# LEE'S SUMMIT MISSOURI

## DESIGN AND CONSTRUCTION MANUAL DESIGN MODIFICATION REQUEST

PROJECT NAME: StorageMart 156

#### PROPOSED CONDITION DRAINAGE AREA MAP

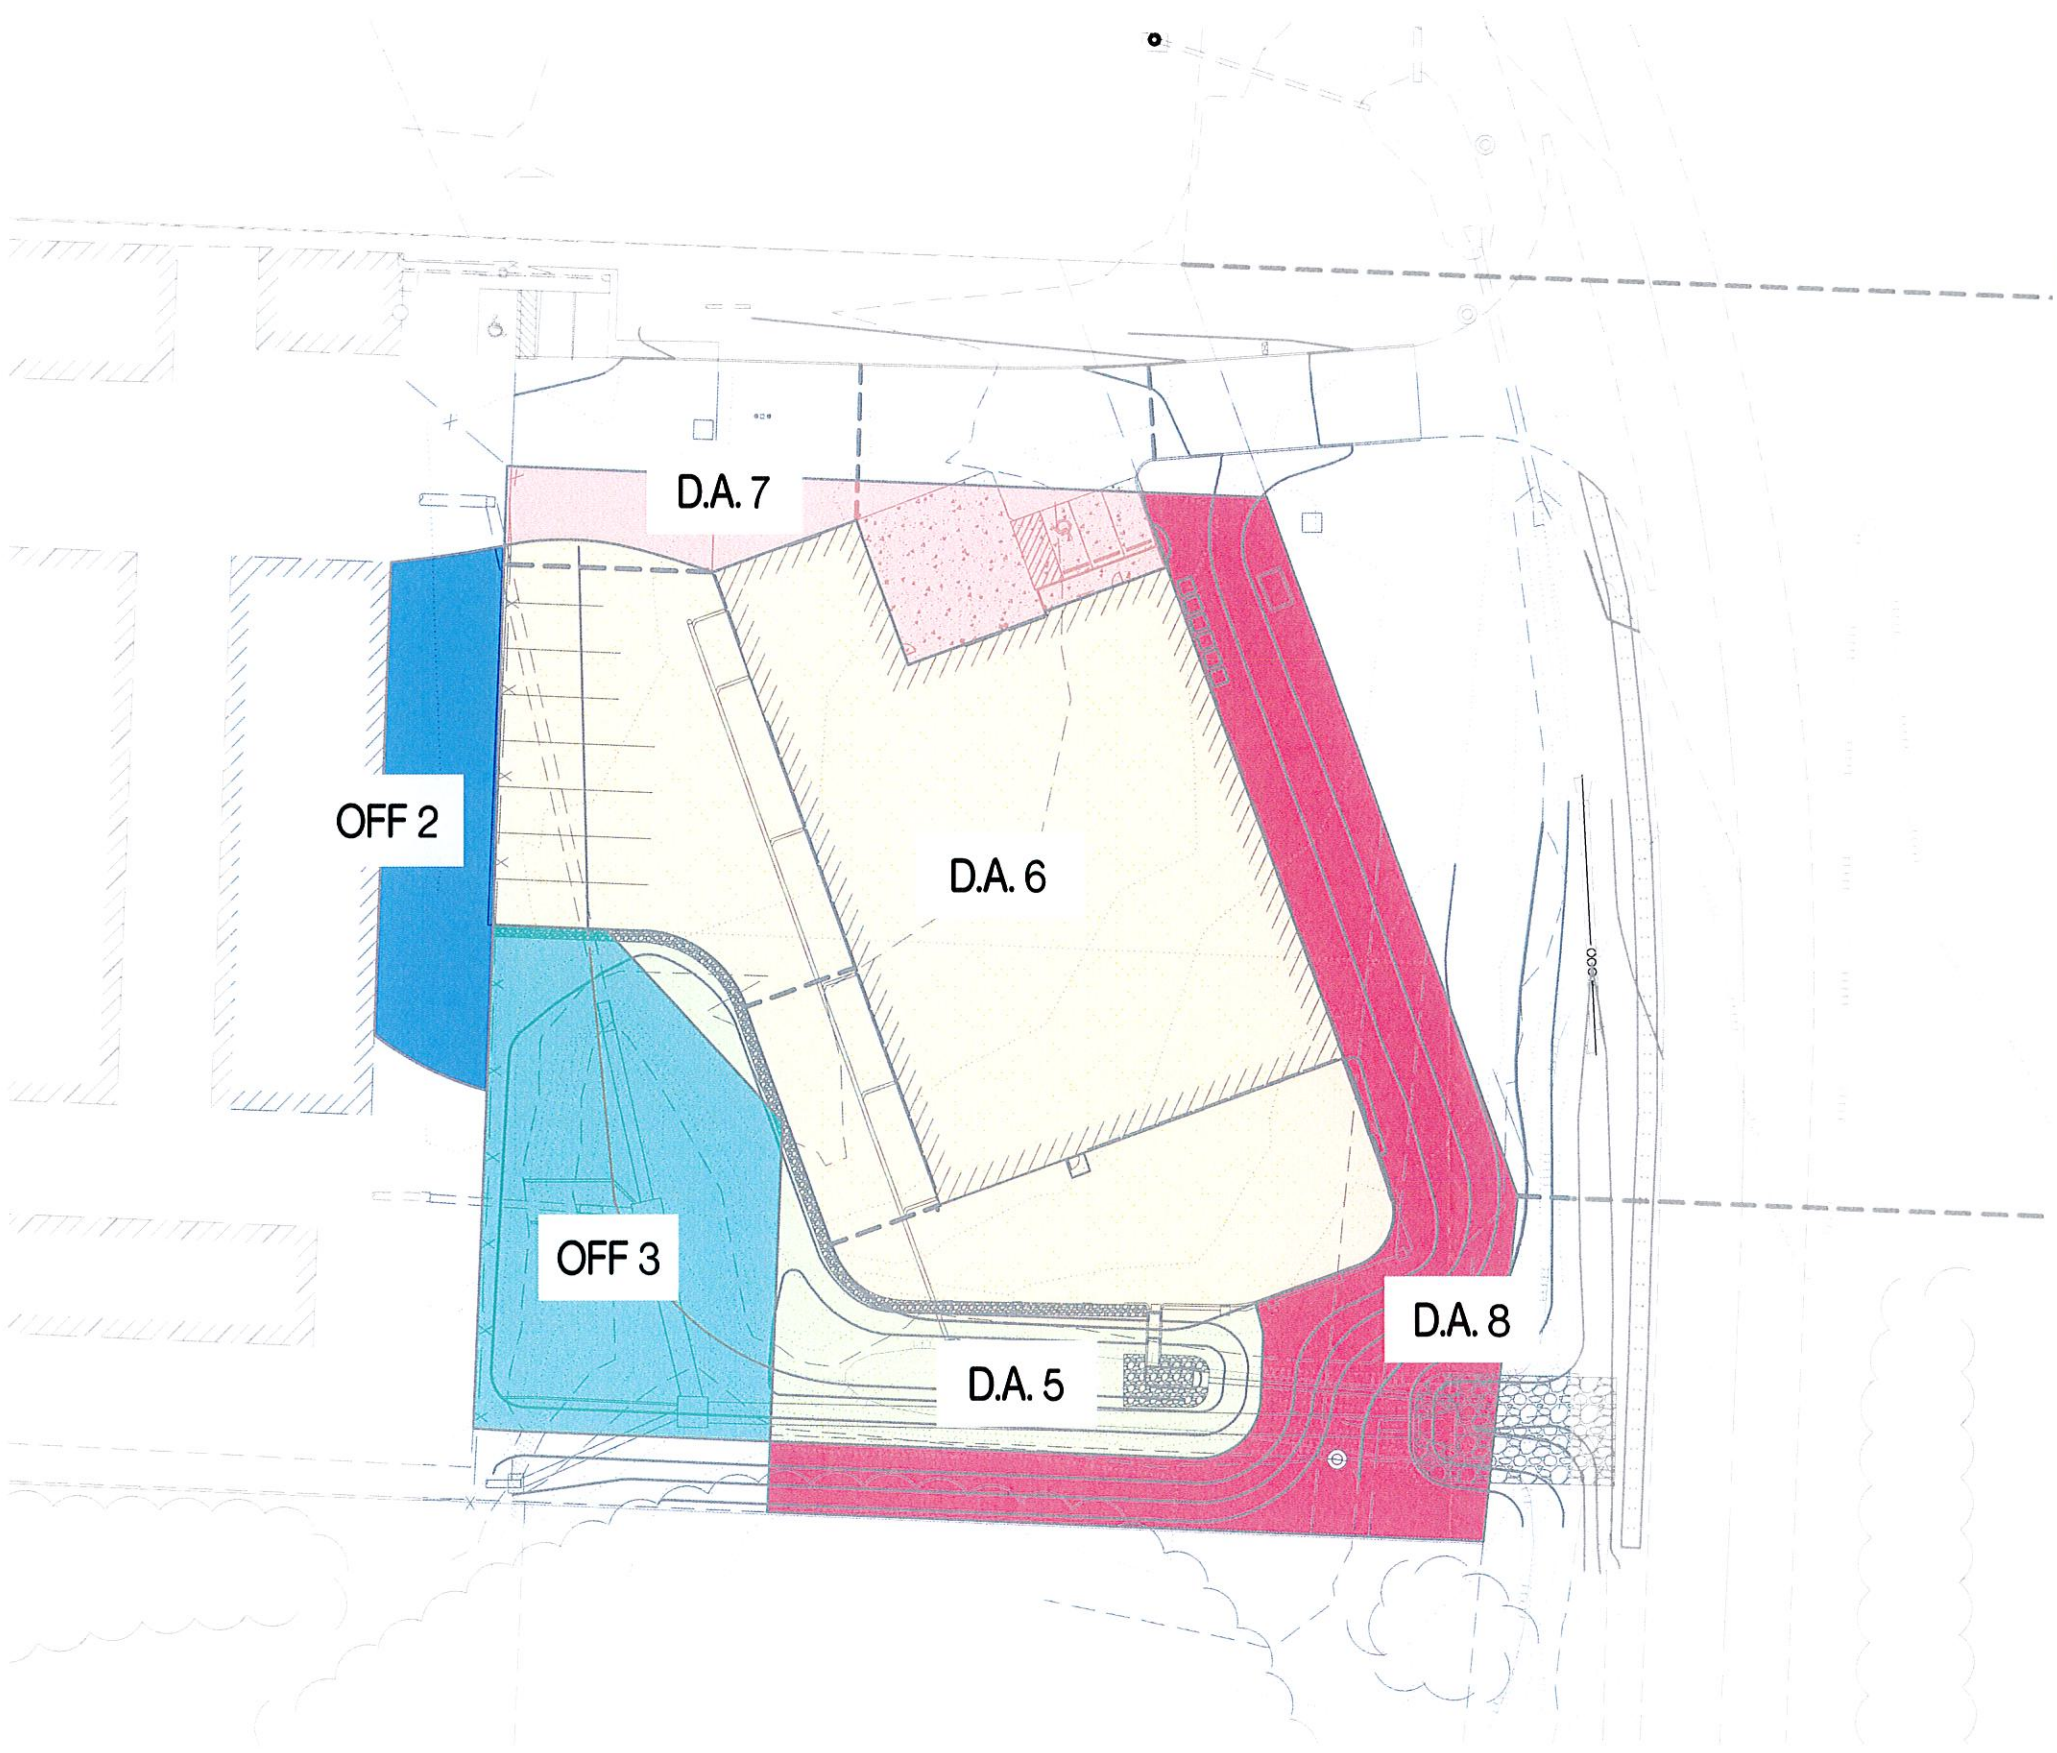
Due to site constraints it is requested that the combined allowable stormwater discharge to exceed the APWA 5600 allowable release rate. The majority of the proposed impervious area will be routed through the detention facility with the exception of 0.10 acres of pavement located north of the building and as depicted on the proposed condition drainage area map (Appendix A2). There will be 0.09 acres of exiting pavement area that will be routed through the detention facility that was previously not being detained. Both these area go to the same watershed therefore by almost treating the equivalent area there will be little to no increase in impervious areas that are not routed through the detention facility. Also, the grass areas located along the east side of the proposed building and south side of the detention facility cannot be detained due to site grades. Due to these areas not being able to be detained by the proposed detention facility the post developed runoff for the entire site exceeds the APWA 5600 release rates. As shown in the tables above the detention facility release rate does meet these requirements and the post developed condition does not exceed the predeveloped condition runoff rates.

For the detention facility the detention outlet structure is required to have a minimum orifice size of 1" diameter. For water quality a 40 hour detainment is required. The detention facility cannot meet both of these requirements. A waiver for a slight reduction to the 40 hour detainment is being requested. This will allow for a 1" orifice to drain the pond in approximately 37 hours.

GEORGE BINGER III, P.E. – CITY ENGINEER: ☒ APPROVED ( ) DENIED
